BOARD OF APPEAL REFERRALS

July 6, 1978

TO: BOSTON REDEVELOPMENT AUTHORITY  
FROM: Robert F. Walsh, Director  
SUBJECT: BOARD OF APPEAL REFERRALS

Z-4199-4200  
511-515 CUMINS HWY.  
(ROS.)

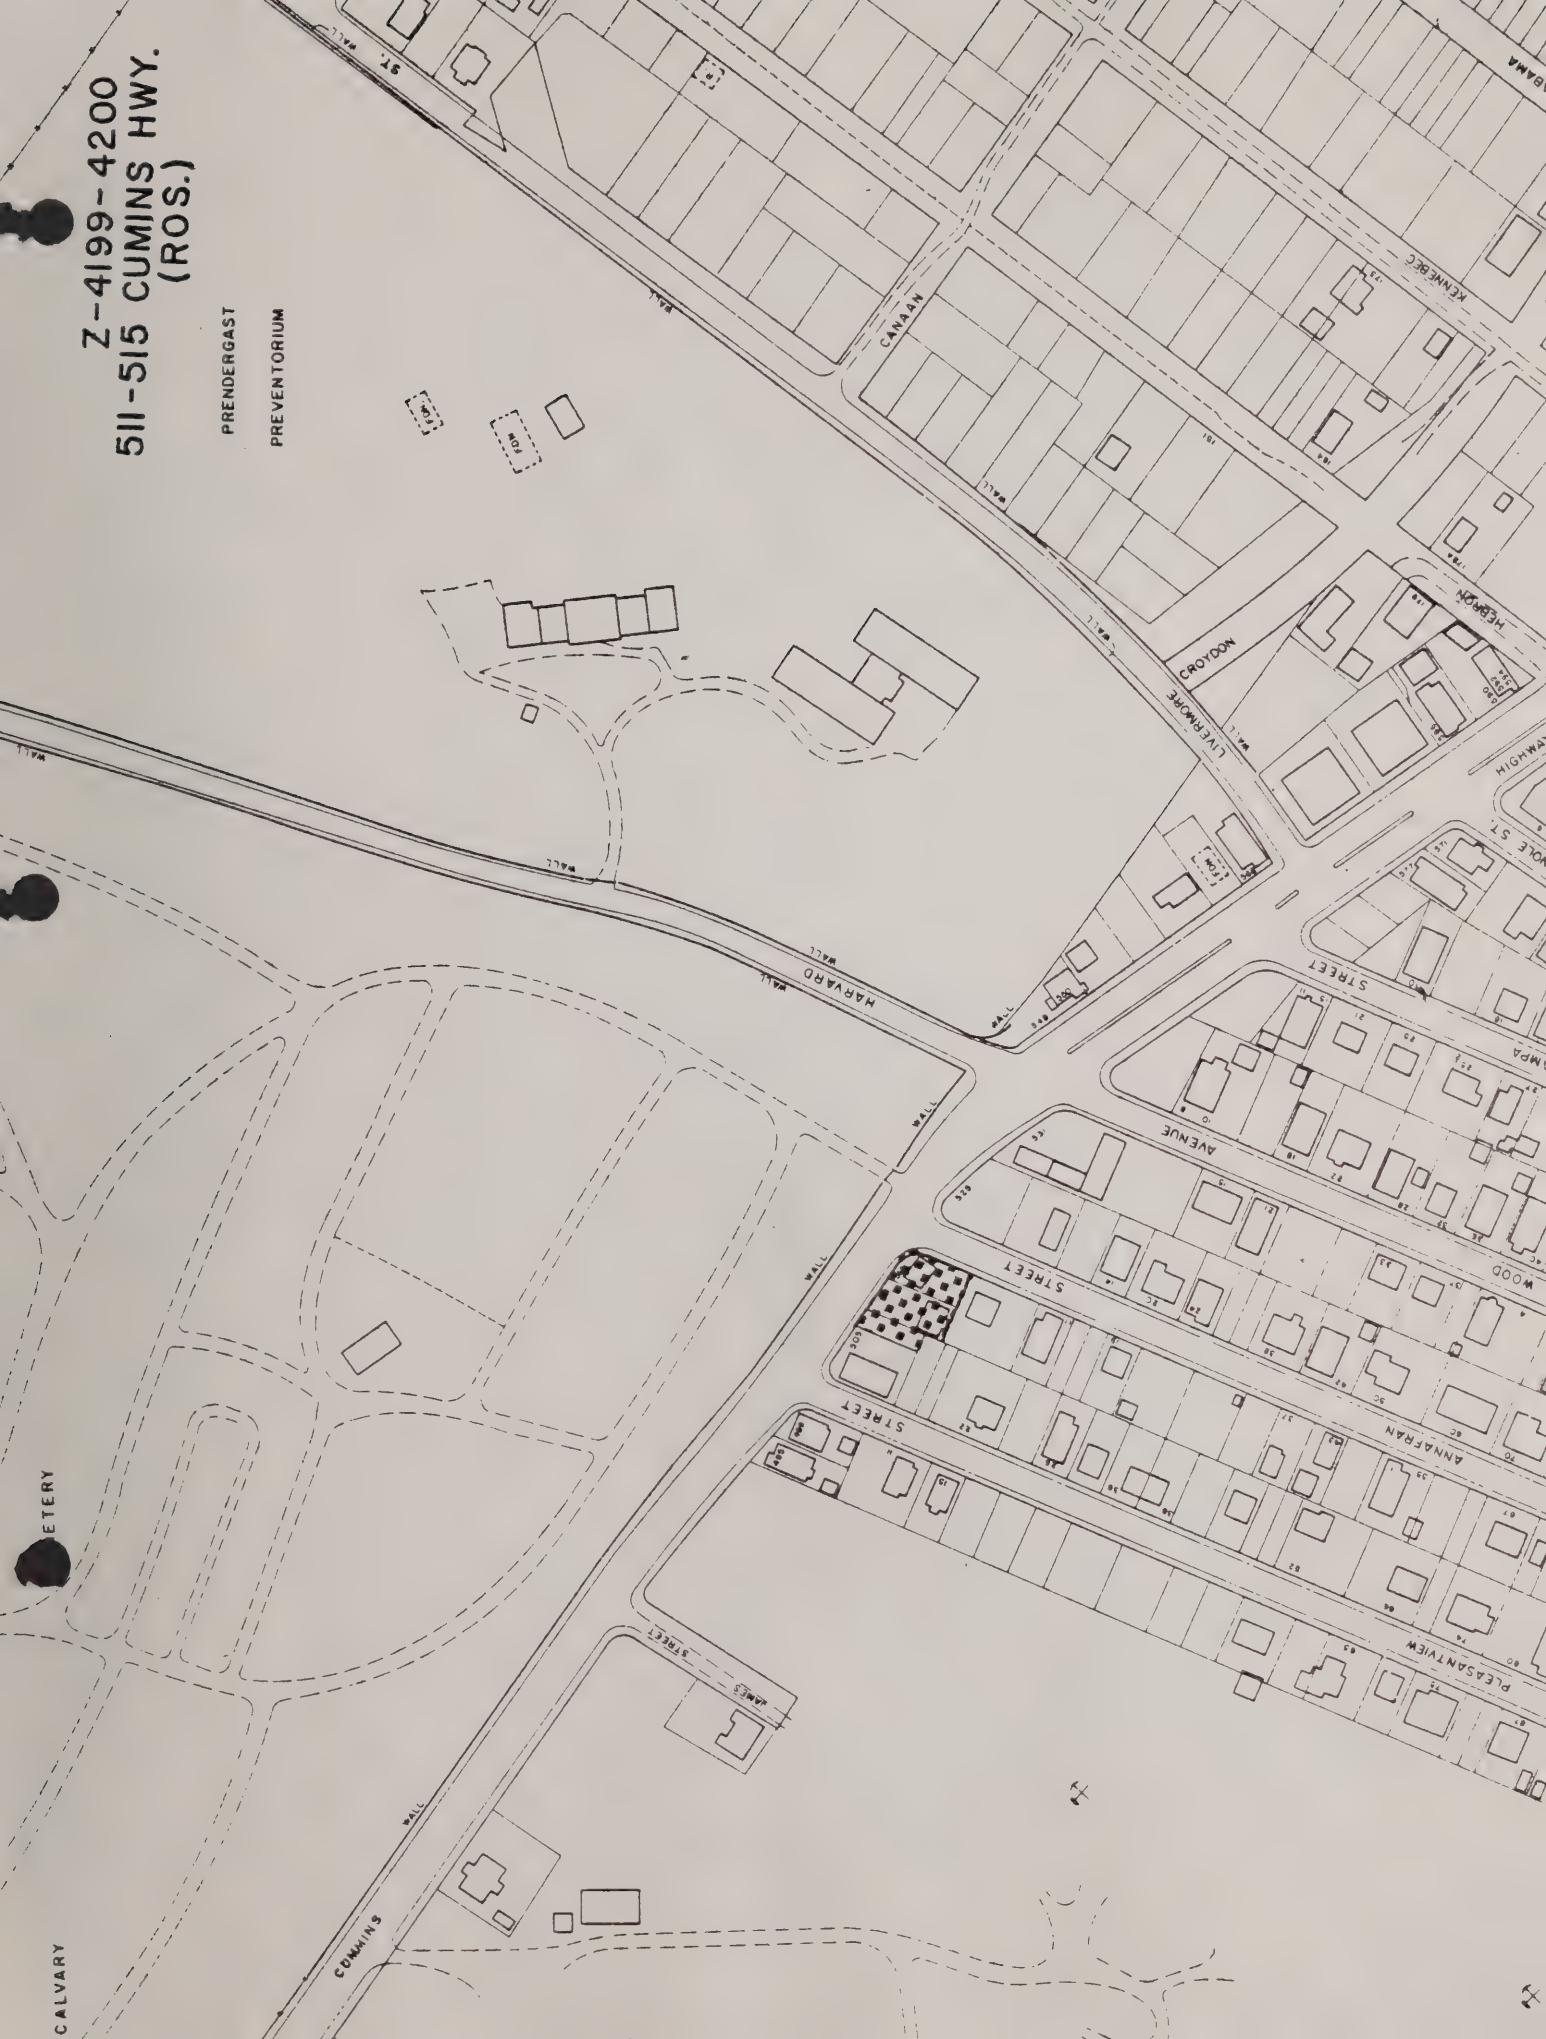
Buildings will be occupied for use as television repair facility.  
Proposed rear addition would have an adverse impact on abutting  
residential property. Recommend approval of combining properties  
and denial of addition.

VOTED: In reference to Petitions Z-4199-4200, brought  
by Joseph W. Higgins, 511-515 Cummins Highway,  
Roslindale, for two forbidden uses, a change  
in a nonconforming use, and three variances to  
combine lots and buildings and erect a one-story  
addition in a single-family (S-.5) district, the  
Boston Redevelopment Authority recommends approval  
of combining properties and denial of addition,  
which would have an adverse impact on adjacent  
residential property.
